DII Response to Comments by EPA to "Description of Off-Site Groundwater Sampling Activities"

20 October 2016

Photo 1: Off-site irrigation well stick-up and associated control panel.

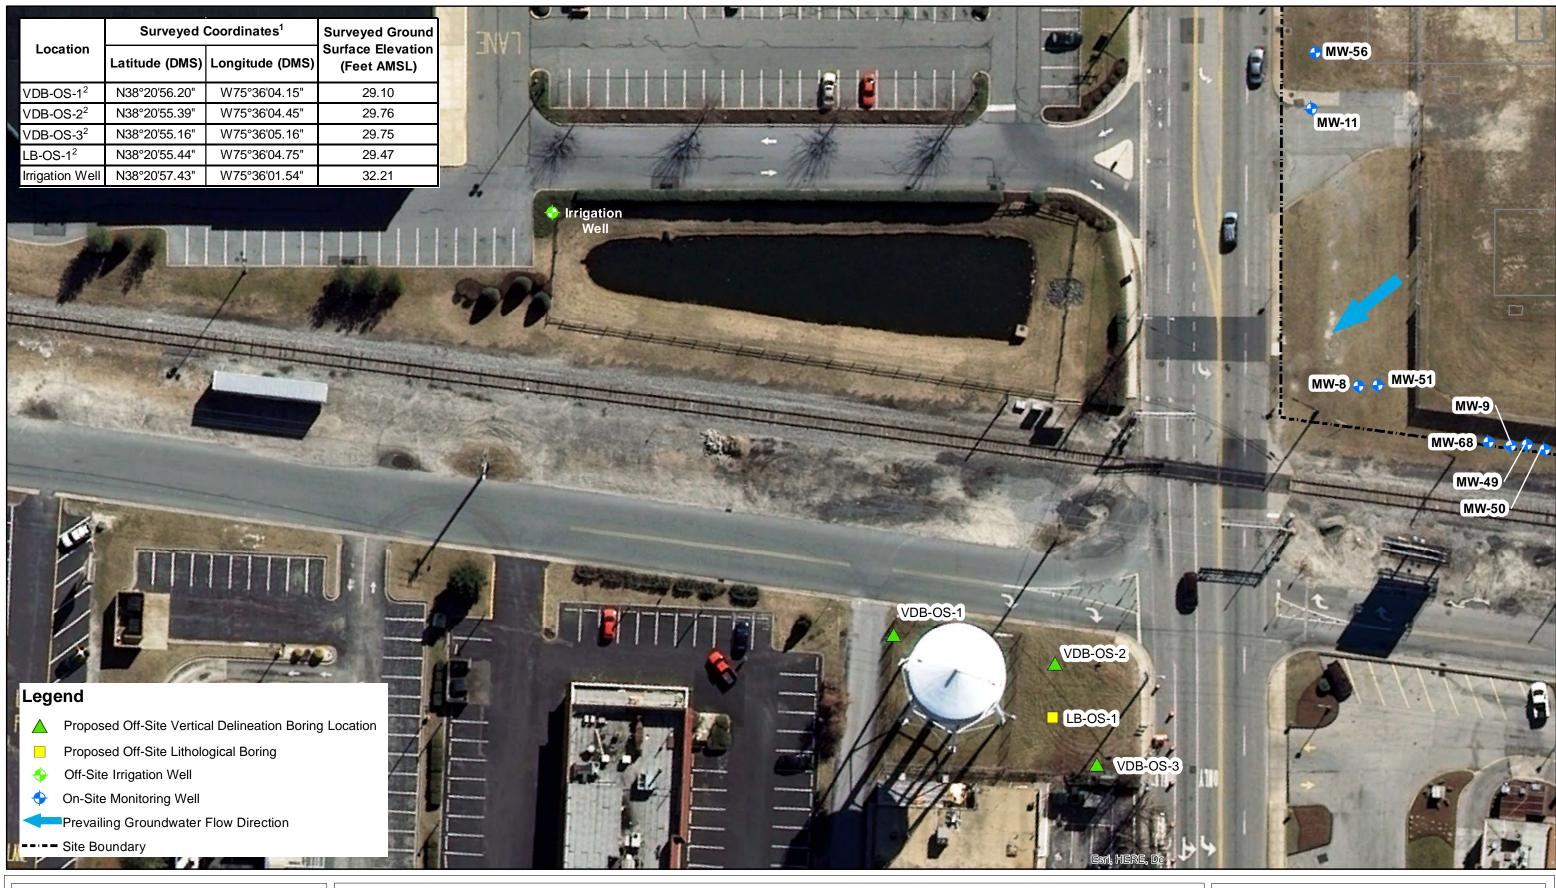
EPA Comment 1: To the extent available and practical, prior to collecting a sample from the irrigation well, per EPA Geologist request, provide to the EPA RPM and Geologist (Mike Cramer), for a quick turnaround review, a description of the geology associated with the irrigation well. Additionally provide a description of the construction, diameter, and depth of the irrigation well, and any associated geology and/or well construction logs. (As EPA RPM will not be available through much of the week of October 10, 2016, please request quick review of the geology directly from EPA Geologist, Mike Cramer (e-mail Cramer.mike@Epa.gov and confirm receipt of e-mail via phone 215-814-3446) and cc EPA RPM- where a quick review is within at least 8 in-the-office hours that Mike has available following verbal or electronic confirmation of contact with Mike. Mike is not in the office every other Friday- including 10/7/2016.)

PII Response: DII is providing below the information that it has in its possession regarding the irrigation well that is located on the College Square Shopping Center property. Information obtained from third party sources as part of a well search performed by ERM in 2009 indicates that the irrigation well (i) was completed on 23 July 1998; (ii) has a well permit number of WI-94-1991; (iii) is four inches in diameter; (iv) was completed using a stick-up polyvinyl chloride ("PVC") casing; (v) is 70 feet deep with casing extending to a depth of 60 feet below ground surface ("bgs"); (vi) has ten feet of plastic well screen extending from 60 feet bgs to 70 bgs; (vii) is located approximately 200 feet from West College Avenue; (viii) can sustain a pumping rate of 75 gallons per minute; and (ix) is permanently equipped with a submersible pump and associated equipment that is connected to the irrigation system installed on the property. The surface completion and well permit number for the irrigation well was confirmed by ERM in February 2016 as documented in the attached photographs.
